Product/Process Change Notice (PCN)											
<input type="checkbox"/> Major Change <input checked="" type="checkbox"/> Minor Change											
<p>PCN Number: PCN_UtPoE_20250520</p> <p>Affected Series: WE-PoE</p> <p>Affected Part Number: See table below</p> <p>PCN Date: 2025-02-20 (YYYY-MM-DD)</p> <p>Effective Date: 2025-05-20 (YYYY-MM-DD)</p>	<p>Change Category:</p> <input type="checkbox"/> Equipment/Location <input checked="" type="checkbox"/> General Data <input type="checkbox"/> Material <input type="checkbox"/> Process <input type="checkbox"/> Product Design <input type="checkbox"/> Shipping/Packaging <input type="checkbox"/> Supplier <input type="checkbox"/> Software										
<p>Contact: Product Management</p> <p>Phone: +49 (0) 7942 - 945 5001</p> <p>Fax: +49 (0) 7942 - 945 5179</p> <p>E-Mail: pcn.eisos@we-online.com</p>	<p>Datasheet Change:</p> <input checked="" type="checkbox"/> Yes <input type="checkbox"/> No <p>Attachment:</p> <input type="checkbox"/> Yes <input checked="" type="checkbox"/> No										
<p>DESCRIPTION OF CHANGE:</p> <p>As a datasheet information amendment, Würth Elektronik eiSos will update the pin numbering on the recommended land pattern drawing and u

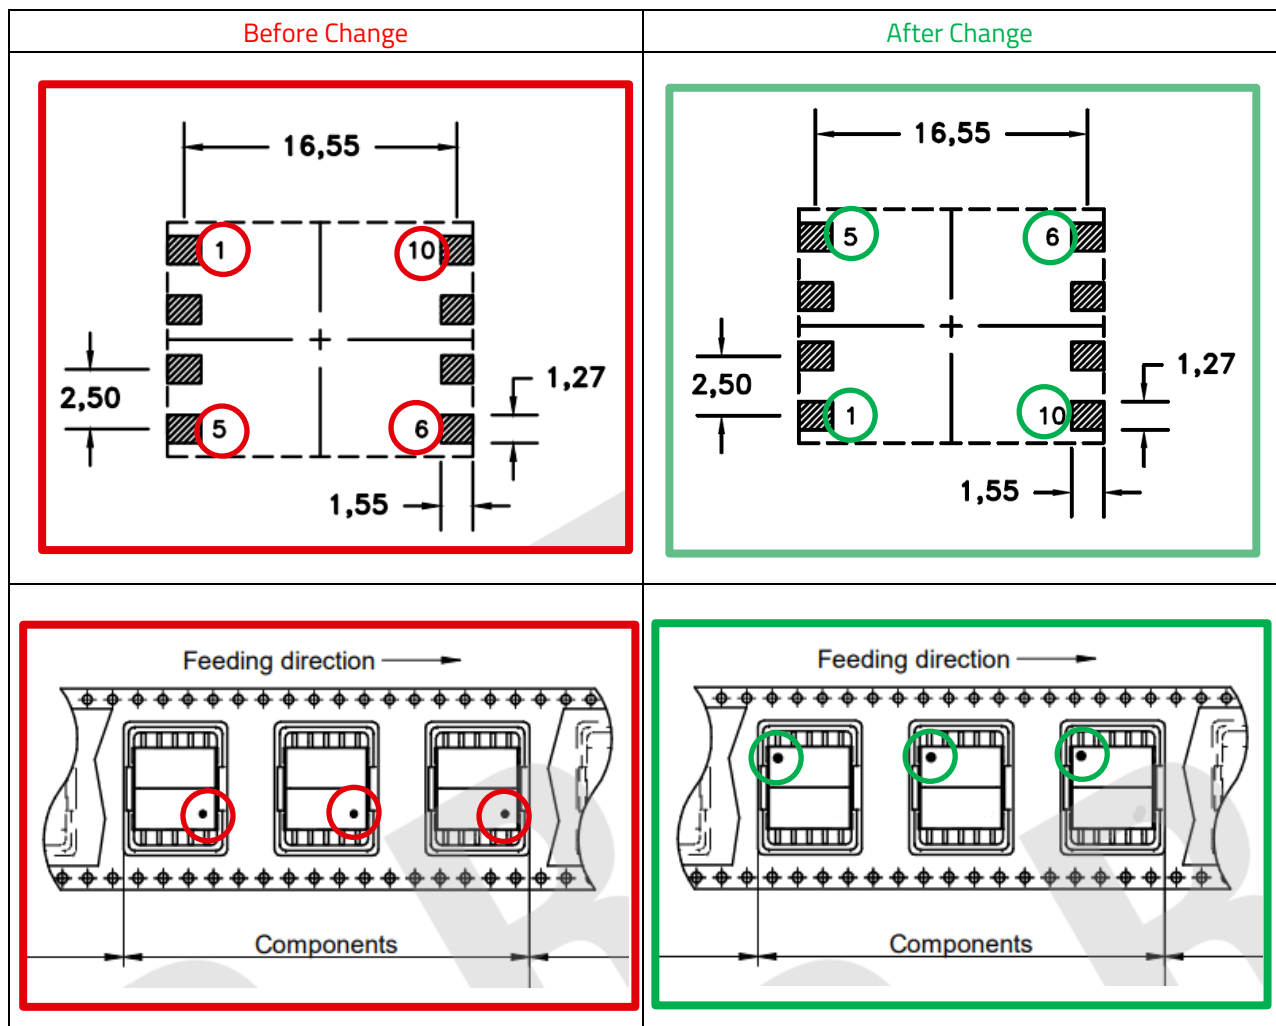
The numbering of the pins has been mirrored along the x-axis to reflect the actual pin numbering of the part. Additionally the location of pin 1 has been moved to reflect the actual orientation of the part in the packaging.
